ROBINSON TRACT RESIDENTIAL DEVELOPMENT STREET ROAD (S.R. 0926) AND NEW STREET CHESTER COUNTY WESTTOWN & THORNBURY TOWNSHIPS

May 15, 2020

RE: Robinson Tract Residential Development Westtown Township, Chester County, PA McMahon Project No. 816451.11

McMahon Associates, Inc. is in receipt of the Township's comment letter, prepared by Albert Federico Consulting, LLC in their capacity as the Township traffic engineer, dated March 13, 2020, in regards to the Transportation Impact Study for the Robinson Tract, prepared by our office and last revised December 2, 2019. It is noted that the applicant was not sent a copy of this letter for review. The development is proposed to be located on the Crebilly Farm property along the west side of U.S. Route 202 (Wilmington Pike), between West Pleasant Grove Road and Street Road (S.R. 0926), in Westtown Township, Chester County, Pennsylvania. On behalf of the applicant, below is a summary of the comments in italics, with our responses following each comment.

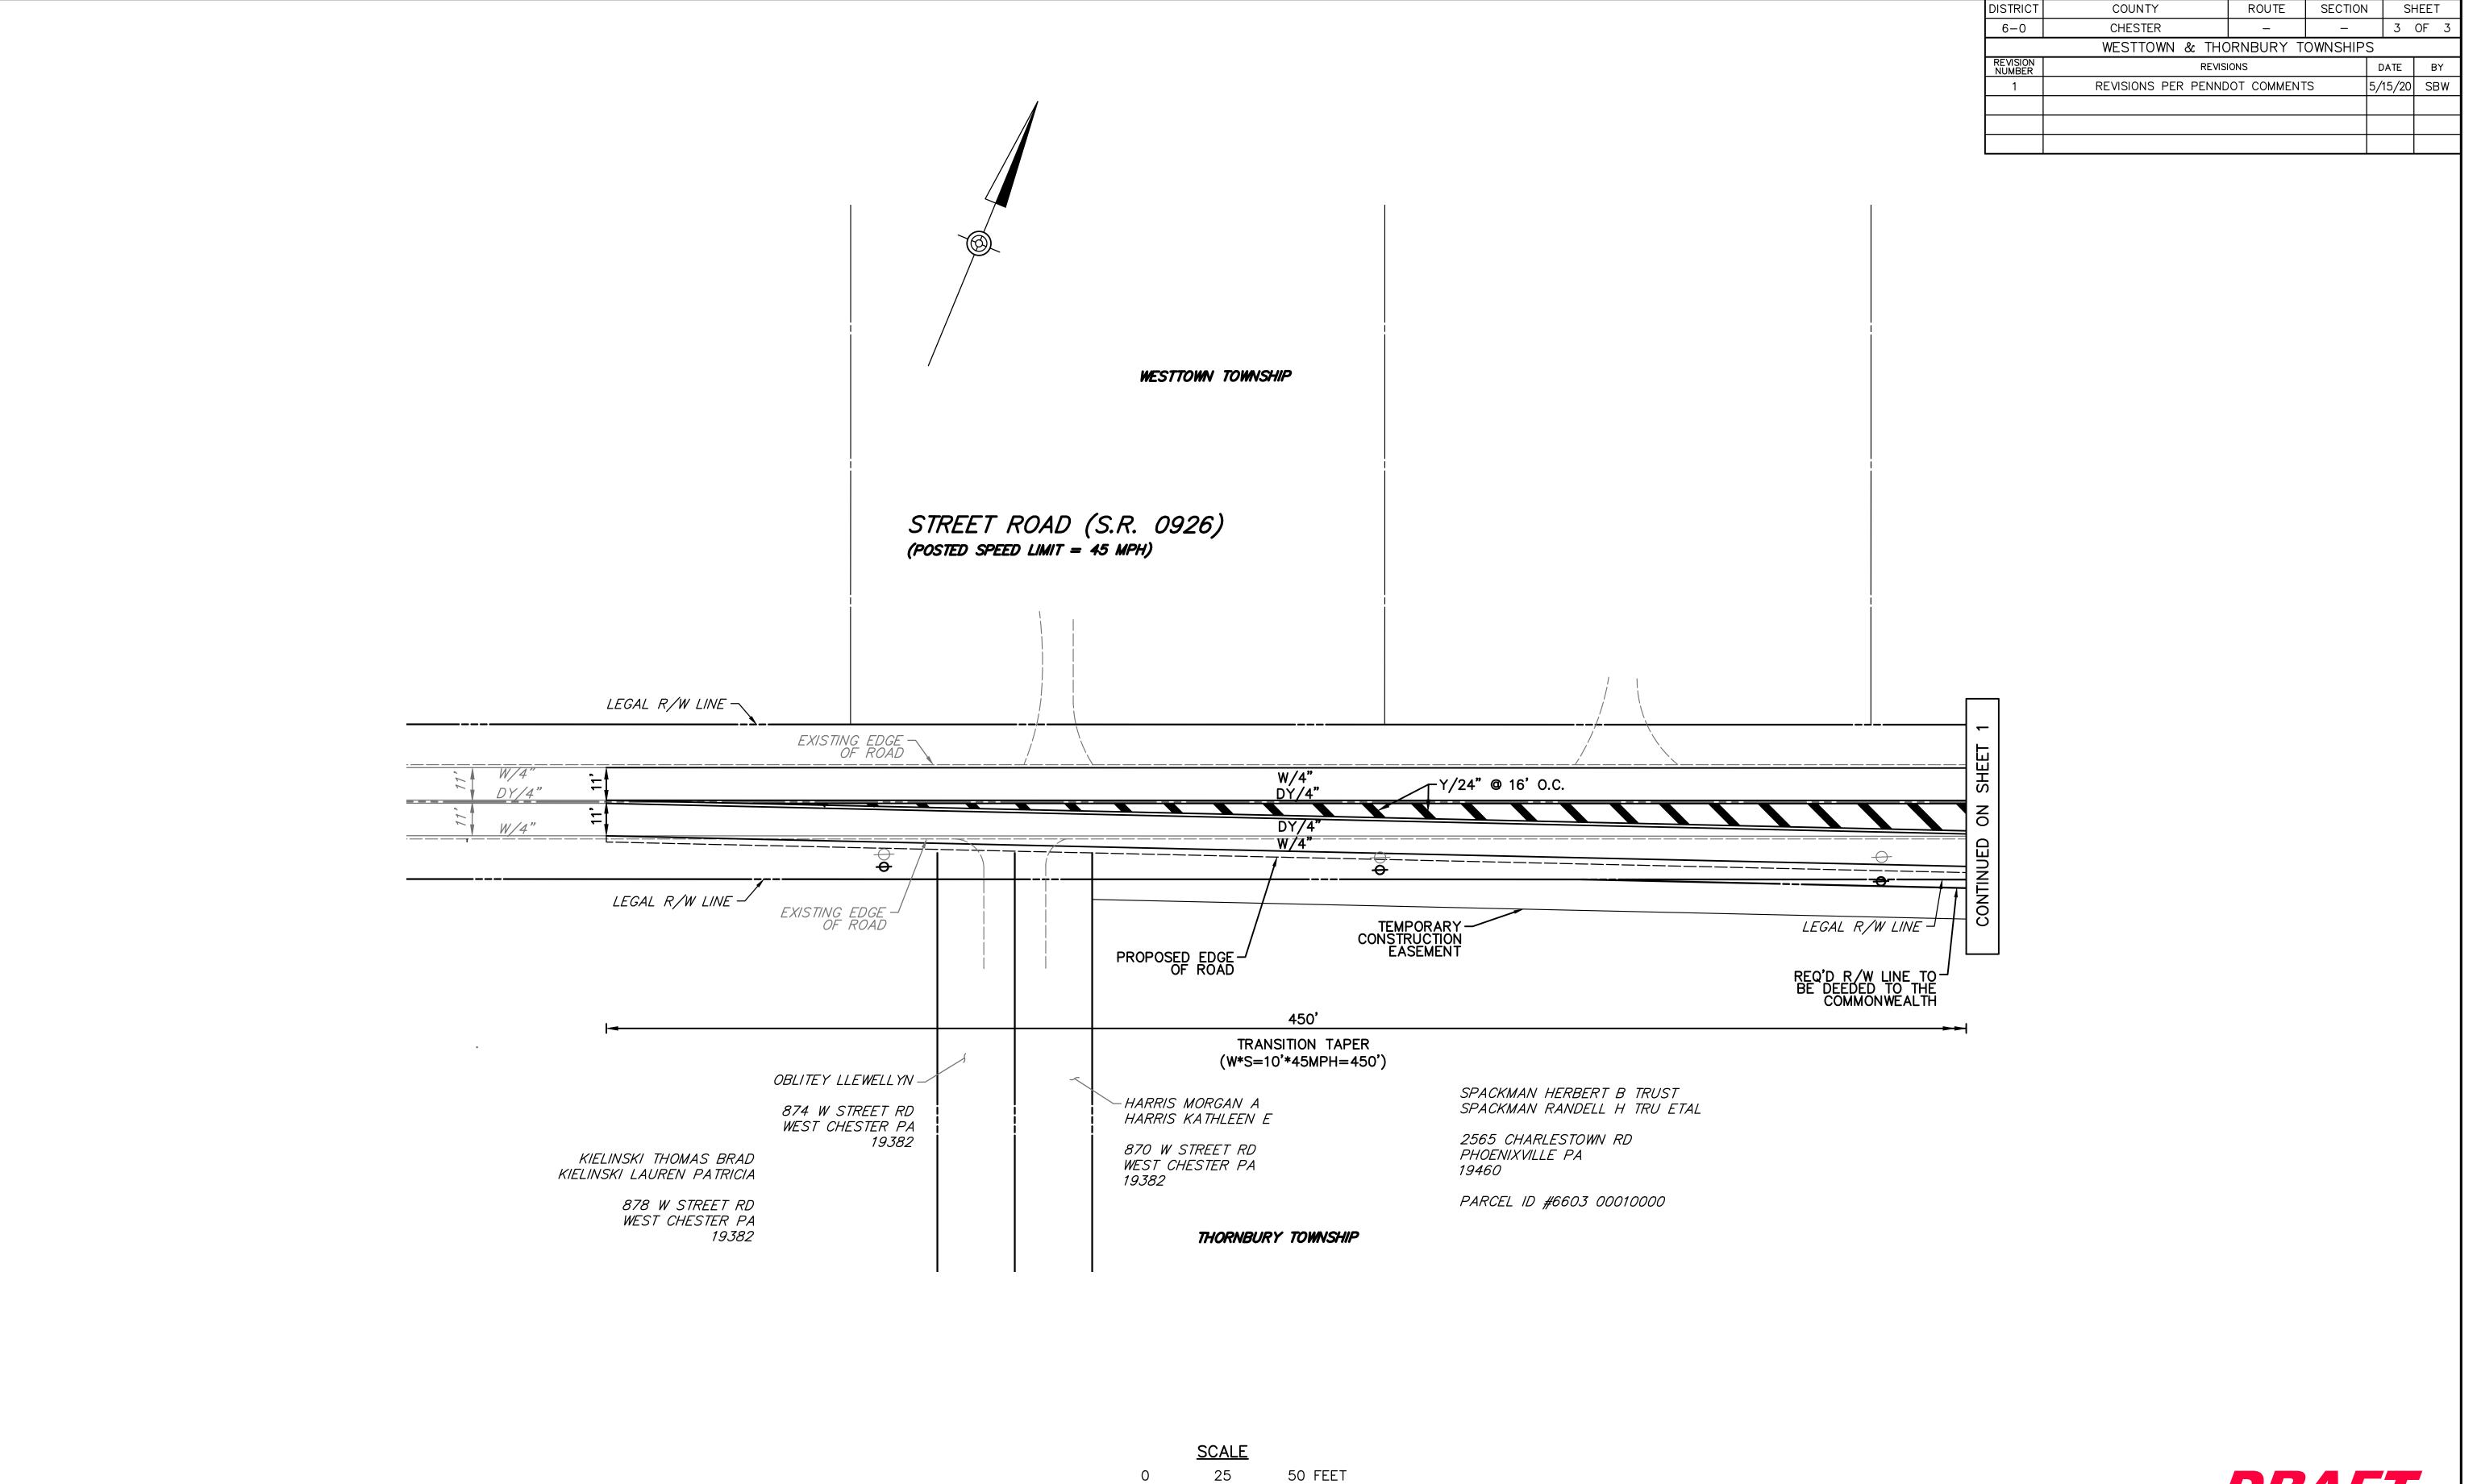
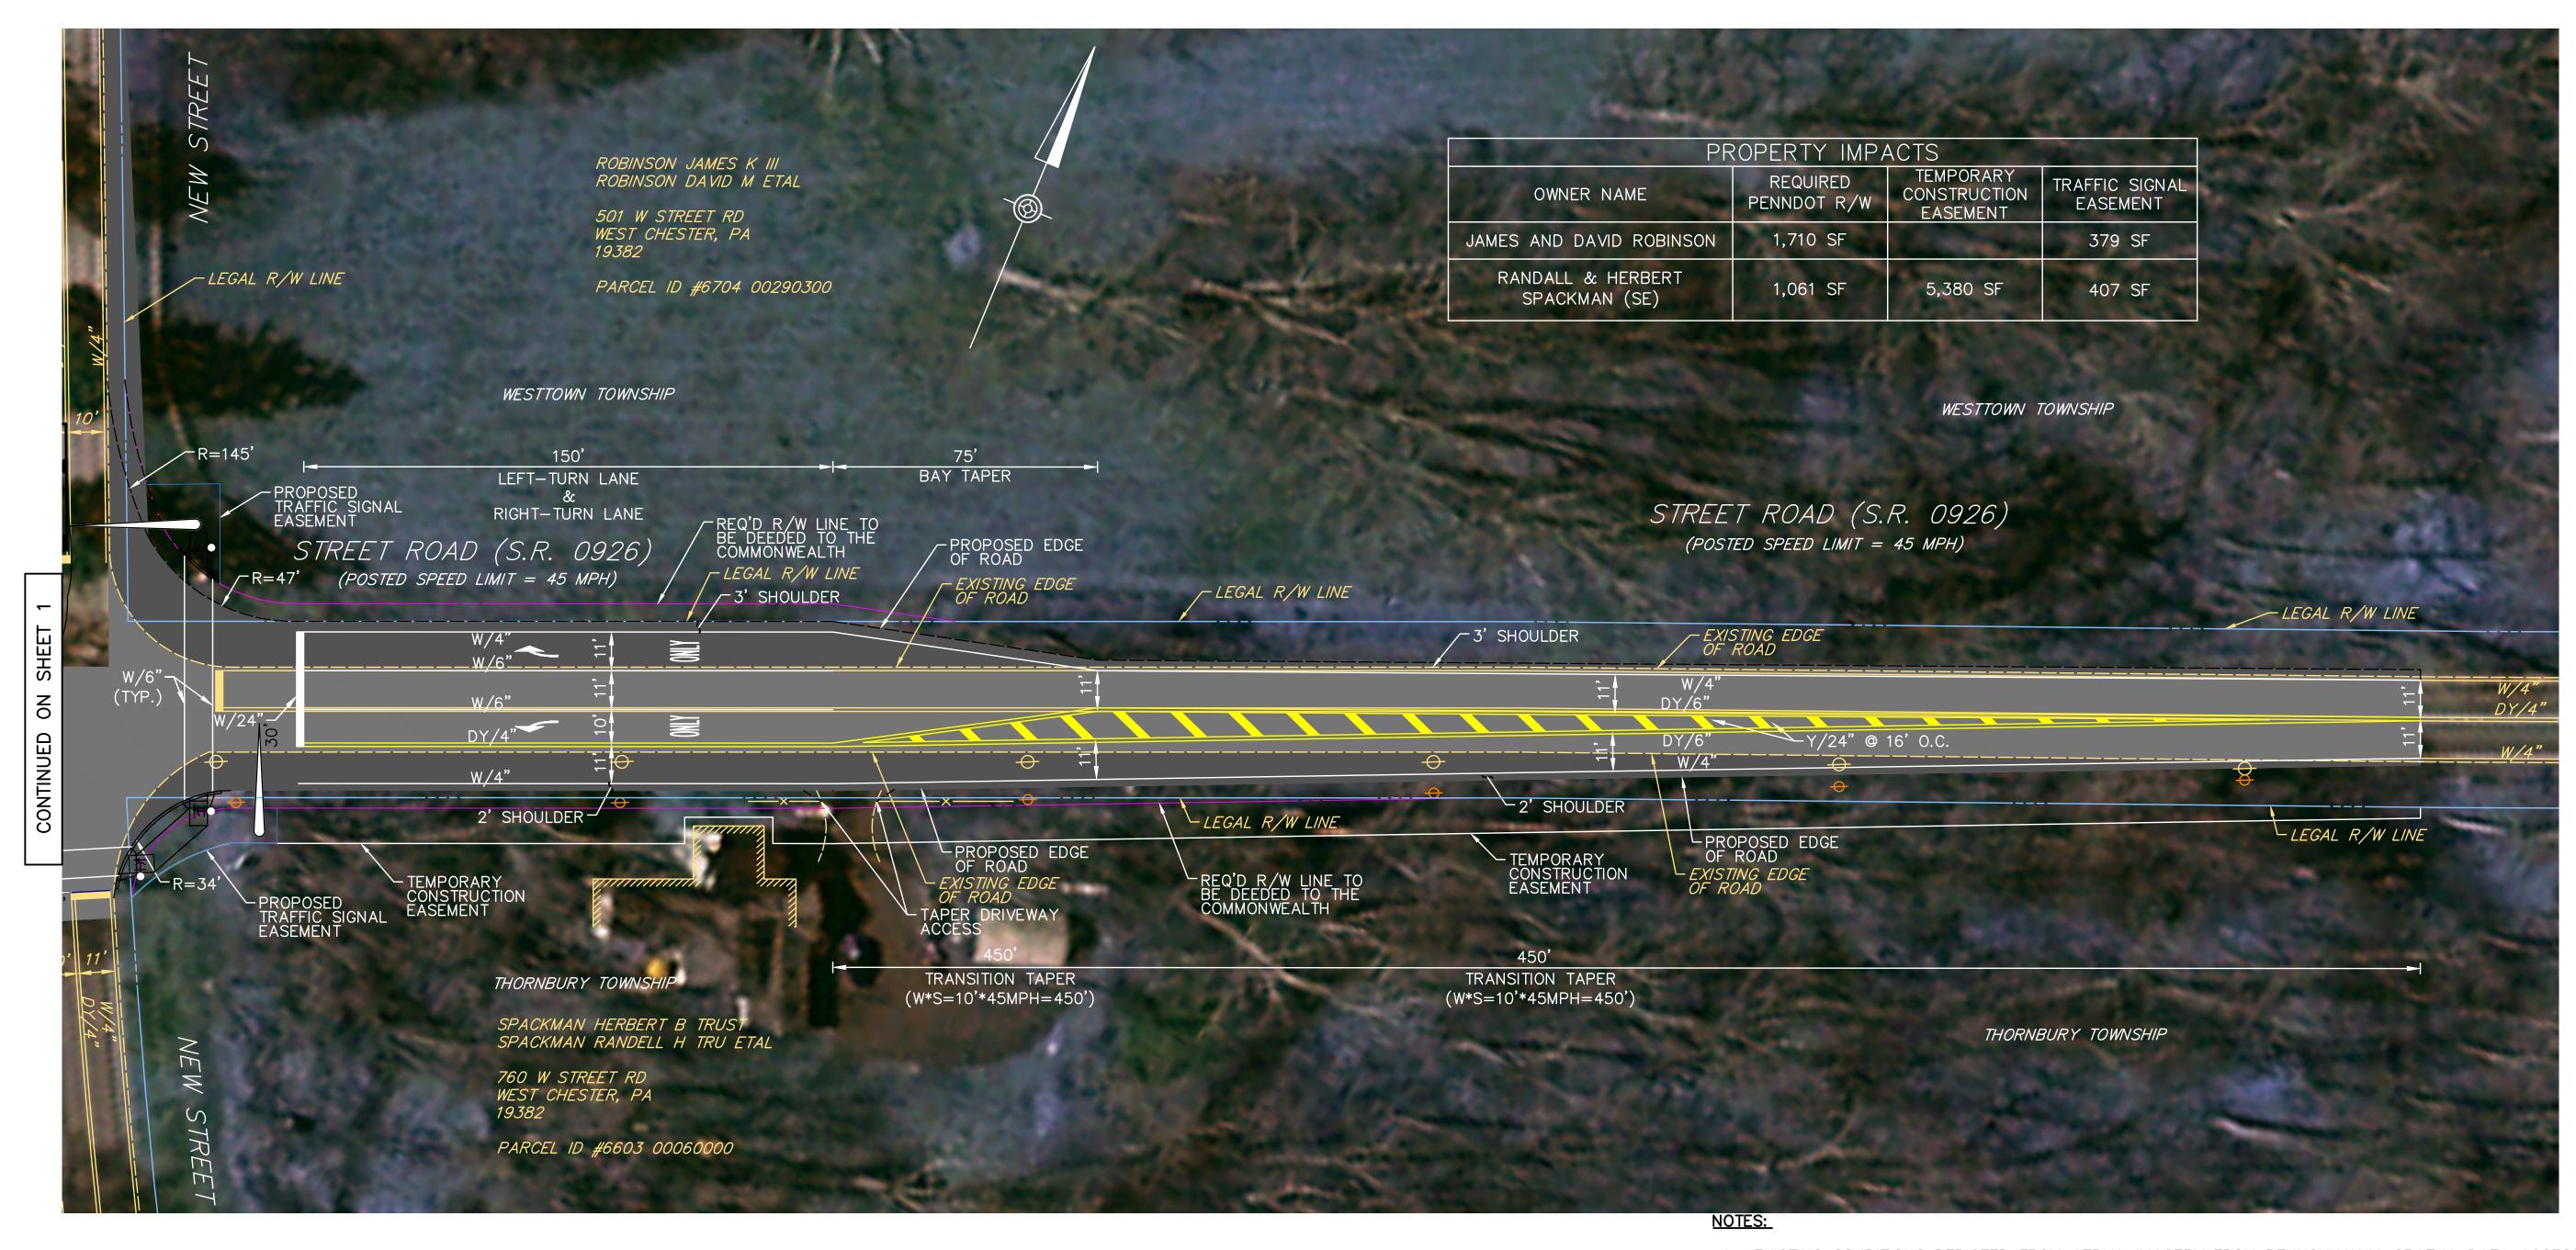
As previously noted, the Cross-Section Assumptions Exhibit for PA Route 926 and New Street in Appendix I is based on a traditional widening. Alternative alignments that minimize the number of properties from which right-of-way would be needed should be considered. Additionally, the Applicant is not precluded from coordinating with property owners to determine if the right-of-way could be reasonably obtained.

Status: The Applicant committed to PennDOT (and represented to the Planning Commission) that revised improvement concept(s) would be prepared for PennDOT and Township review and would be used to coordinate with the potentially affected property owners.

The applicant has submitted a conceptual plan and is continuing to coordinate with PennDOT, Westtown Township, and Thornbury Township regarding improvements at the intersection of Street Road (S.R. 0926) and New Street. Traffic analysis worksheets documenting the results with the additional intersection improvements illustrated in the conceptual plans are attached.
